Shagore Garments Ltd. Optimum Garments Ltd.

Amir Complex, Plot 43, Sector 3, Uttara, Dhaka
(23.867624, 90.399812)
10th March 2014

Column strengths

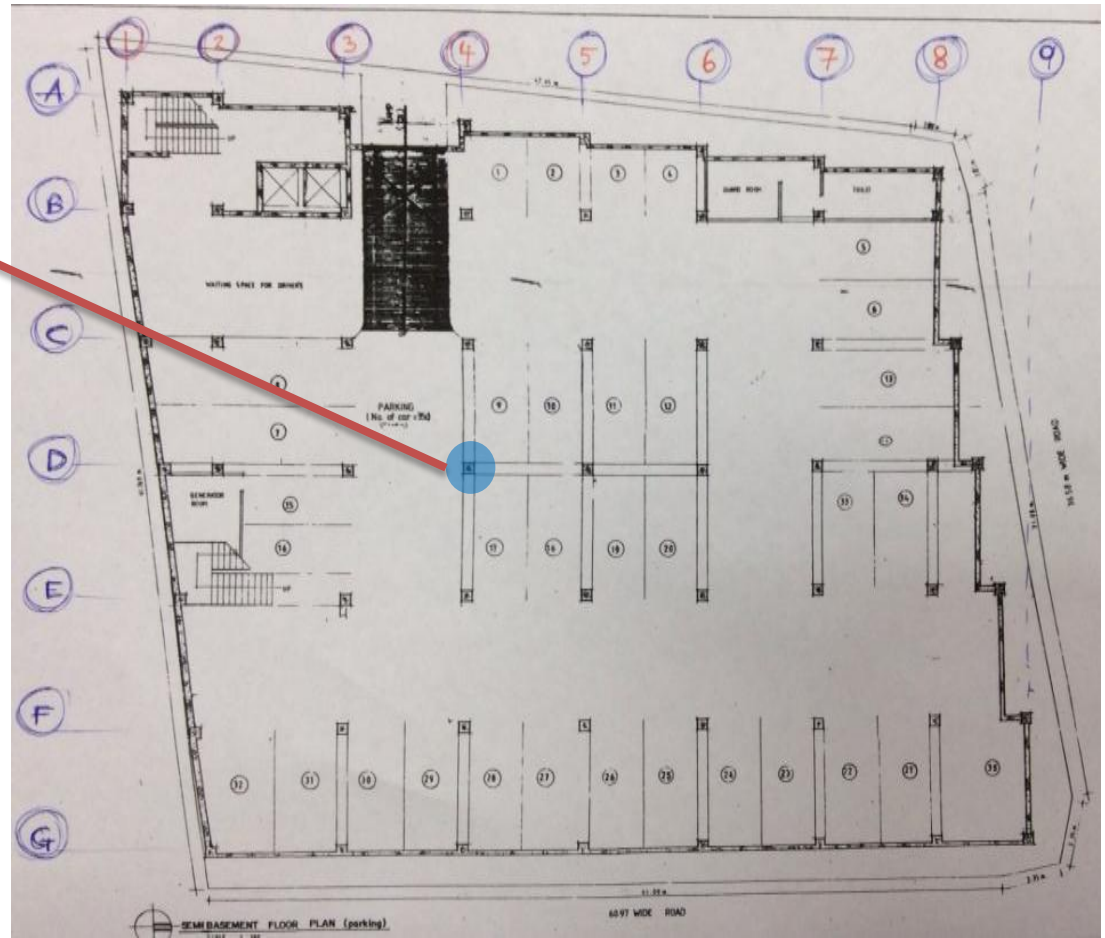
Design drawings are in good agreement with as-built structure. Opening up confirms aggregate type is stone throughout, and scanning on several columns indicates but cannot conclusively confirm high levels of reinforcement in agreement with drawings. Cursory calculations indicate working stress in the columns may be higher than designed for.

Cracking in slabs

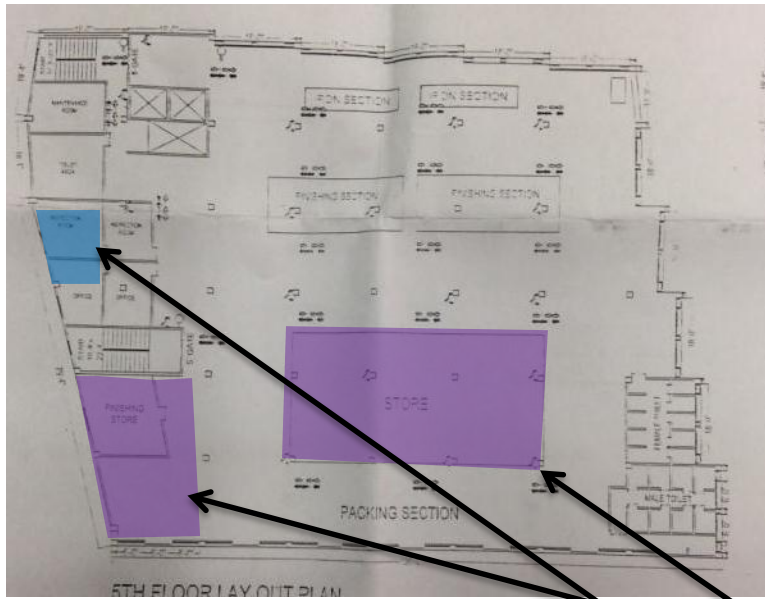
Cracking to undersides and side of beams particularly on L7 but also on other levels. Cracks have been repainted in most locations. Building Engineer to check cracks in beams and define a repair system, if required.

Cracking in downstand beams

Cracking in flat slabs on underside of level 9

Cracking to tops of slabs e.g. on 6th floor

Floor loading – storage areas

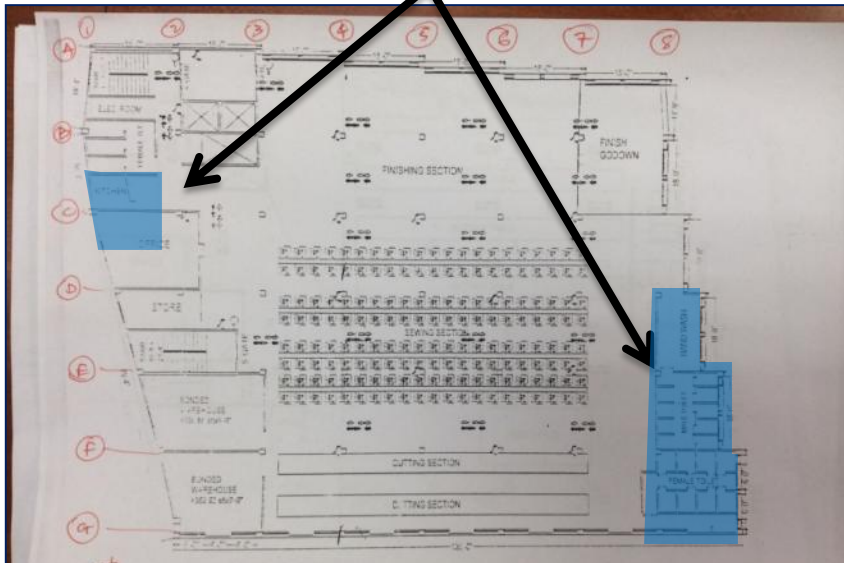
High live loads arising from storage loads and additional tanks e.g. in kitchen area. Selected examples shown below.

Storage areas in the same plan location on most levels

Some kitchen areas with additional tanks on some levels

Loading plans (i.e. plan and height restrictions) to be introduced to prevent future overloading – to be developed by building engineer

Floor loading – market floors

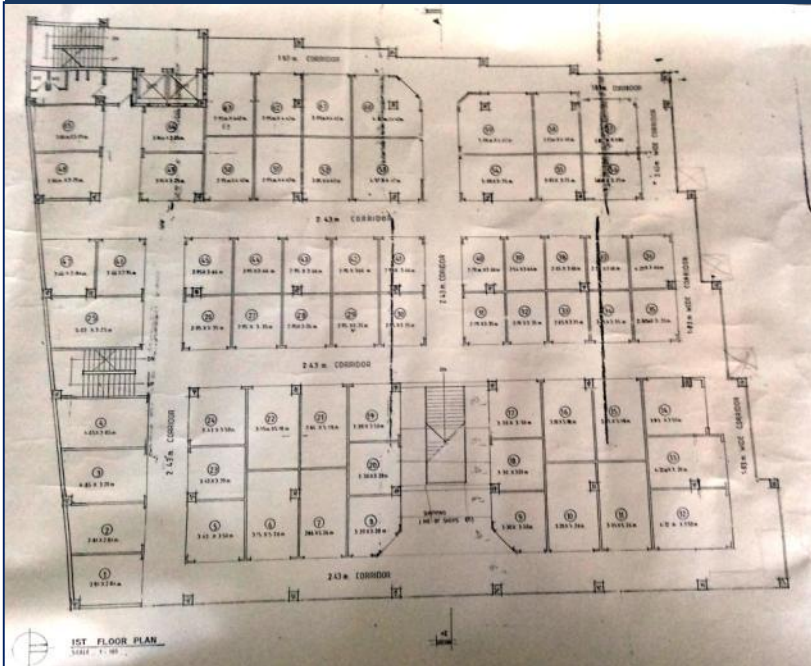
High loads arising from heavy toilet floor build-up, up to 500mm thick

Heavy toilet build-up in these locations on most floors

Dense layout of solid masonry partition walls throughout market area, with possibility of high storage loads once all levels fully occupied

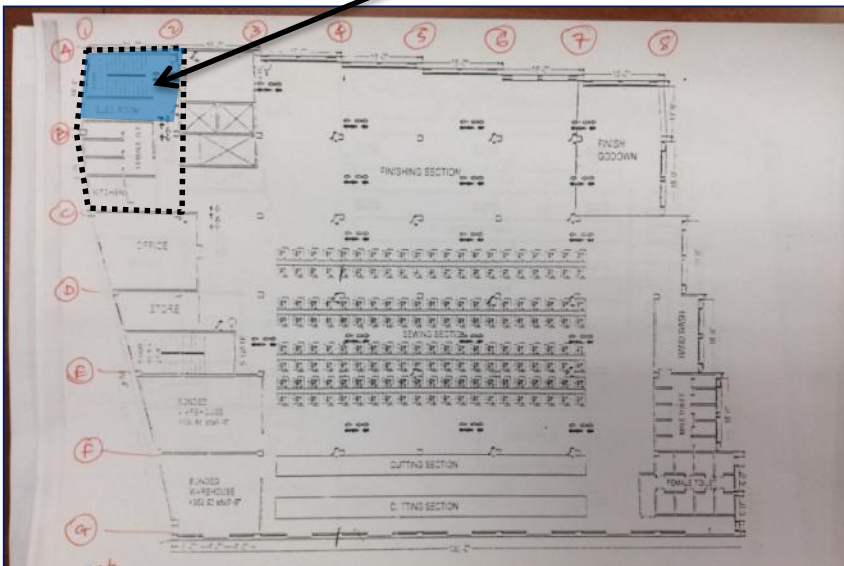
High tank loading on roof levels

Water tank height 2.3m over bay of stair core = 23kN/m²

Large concrete water tank over stair core not shown on drawings adds significant load to supporting structure

Other significant loading also arises from a group of plastic tanks at roof level

Drawings do not match as-built

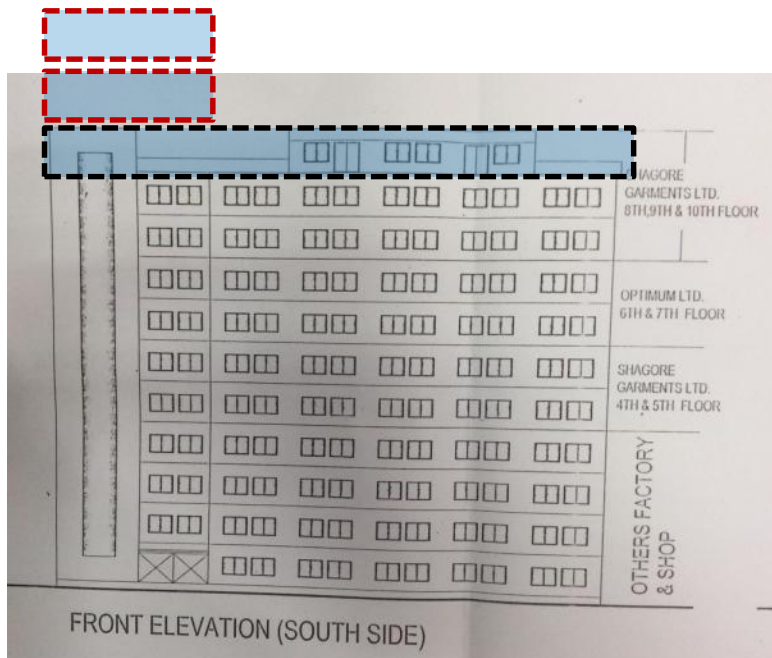
Drawings do not match structure as-built

L10 built completely rather than partially as shown on drawings and additional floor levels built above L10 in localized areas

Structure switches from beam and slab to flat slab only at L9

The drawings do not match the as built structure in several locations. For example, additional floors have been added locally above the stair and lift cores, and the structural system changes at a higher level than the drawings indicate.
